**SACRAMENTO  
HOUSING AND REDEVELOPMENT  
AGENCY**

SUBJECT: Hyatt Regency Hotel-Mall/Public Improvements

SUBJECT: Hyatt Regency Hotel-Mall/Public Improvements

HYATT REGENCY HOTEL PUBLIC IMPROVEMENTS PROJECT  
REVISED PRELIMINARY DESIGN PLAN AND  
DESIGN/CONSTRUCTION MANAGEMENT SERVICES

K STREET AND 13TH STREET MALL REDEVELOPMENT PLAN

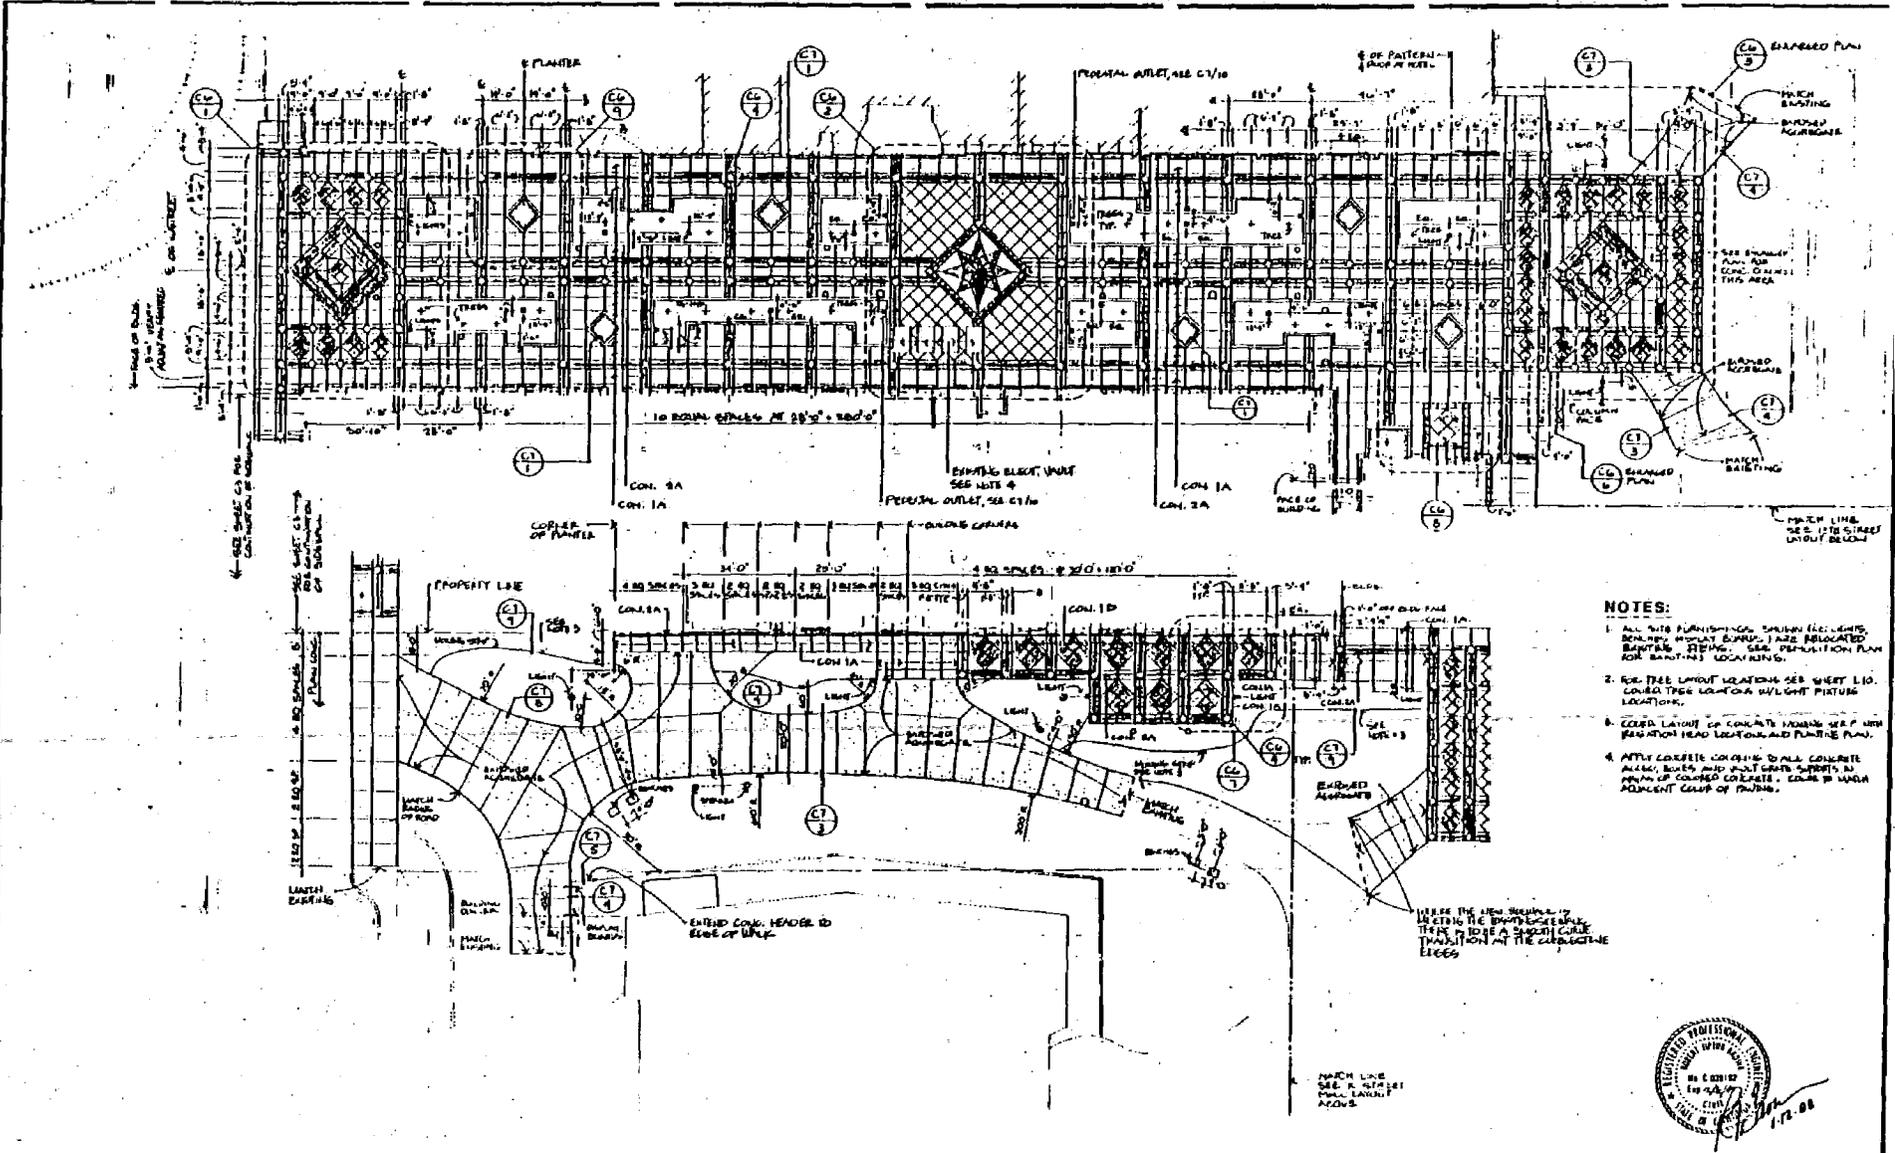
The Preliminary Design Plan was reviewed by the City Design Review Board on December 9, 1987. The Board raised a few concerns regarding the color, texture and materials of the proposed surface treatment. The Board also requested to review the landscaping, irrigation and exterior lighting plans for the proposed public improvements. To address the color, texture and material concerns, the Board appointed a three-member subcommittee to review actual color, texture and material samples poured on the project site. The appointed subcommittee and representatives of the City, Agency, developer and contractor met on the site on December 16 and 23, 1987 to review several actual sample pours. Based on these meetings a consensus was reached as follows:

1. The bands shall be colored with Bomanite, with a broom finish. The surface and score lines shall be as shown on the final construction plans.
2. The diamonds in the bands shall be single pieces of granite to match the wainscot on the hotel building.
3. The fields within the bands on 12th Street and "L" Street shall be colored with Bomanite standard shale gray and stamped with a Bomanite shale texture. The fields shall be scored into four equal quadrants.
4. The fields within the bands on the "K" Street Mall and 13th Street Mall areas shall be colored with Bomanite standard shale gray and stamped with a Bomanite shale texture with the exception of the areas noted where the finish should be a wood float finish. The surface and score lines shall be as shown on the final construction plans.

These changes are reflected in the plans attached as Exhibit II. A large-scale color display plan will be presented at your scheduled meetings.

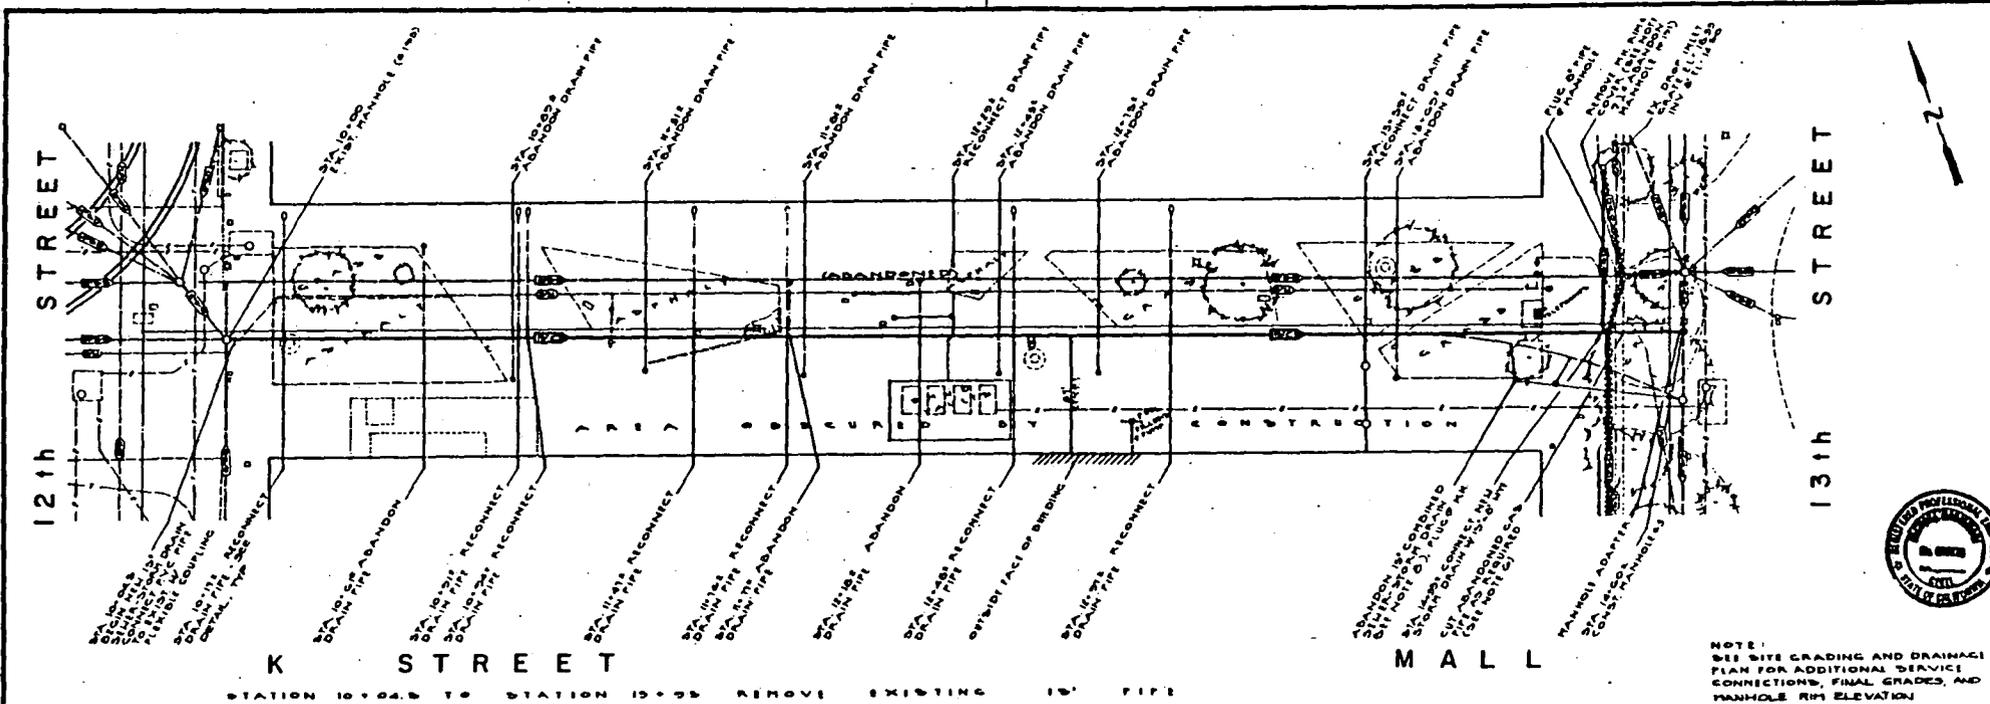
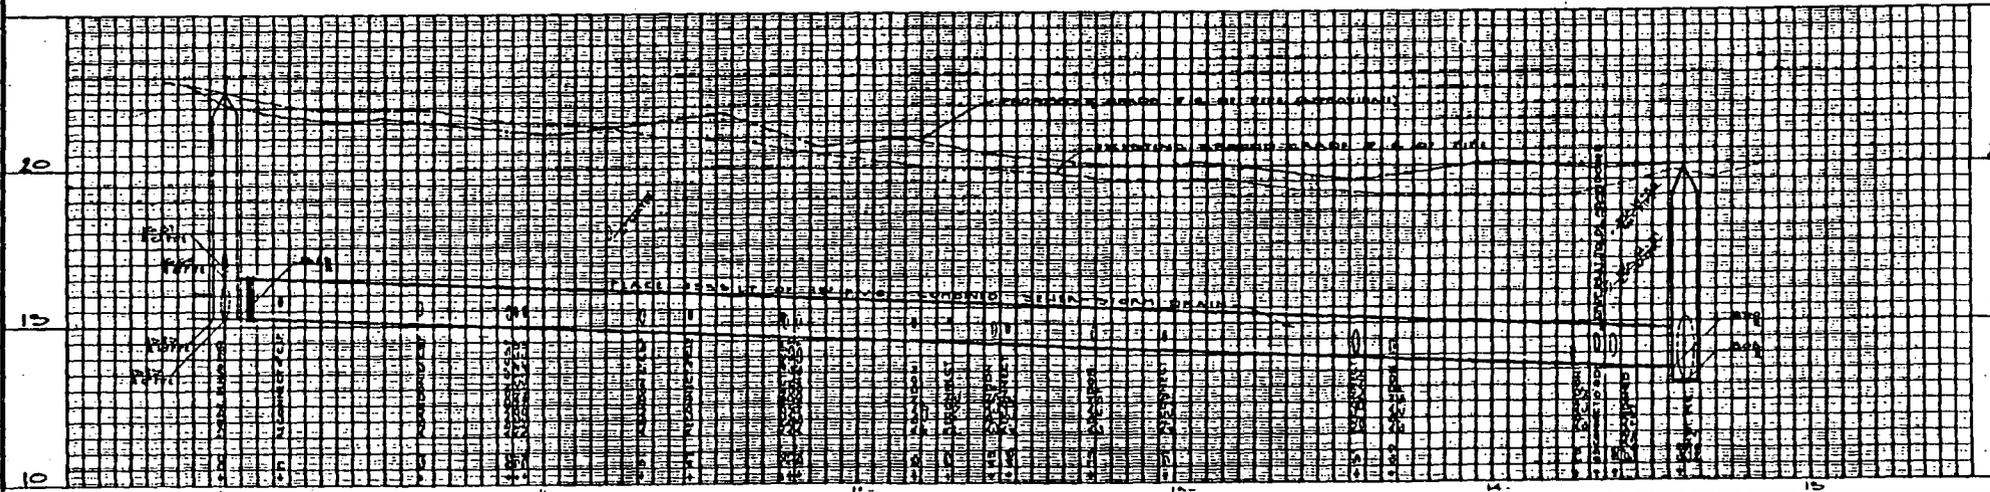
The proposed change in scope of development regards addition of a 15" sewer line replacement along "K" street Mall which is a project that needs to be accomplished prior to the commencement of the "K" Street Mall surface improvements. The City Public Works Department feels it is more appropriate to have this sewer line replacement accomplished as part of the subject public improvement project rather than as a separate project. The City would provide the Agency with sufficient funds from the City Flood and Sewer fund to pay the cost of the sewer line replacement. The developer, JB and LE Venture, is agreeable to include this activity with the overall subject public improvements. At the time a specific cost for the sewer line replacement is determined, the Section 8,(K) of the Hyatt Regency Hotel DDA will have to be amended to reflect the change in scope of development as indicated above.

SECTION 6: CITY agrees to contribute \$235,000 in Major Street Construction Tax funds for the construction of the PROJECT. These funds shall only be used for street related public improvements within the public right-of-way. In addition, CITY agrees to contribute Flood Control and Sewer funds in amount sufficient to construct sewer improvements as delineated in Exhibit A.
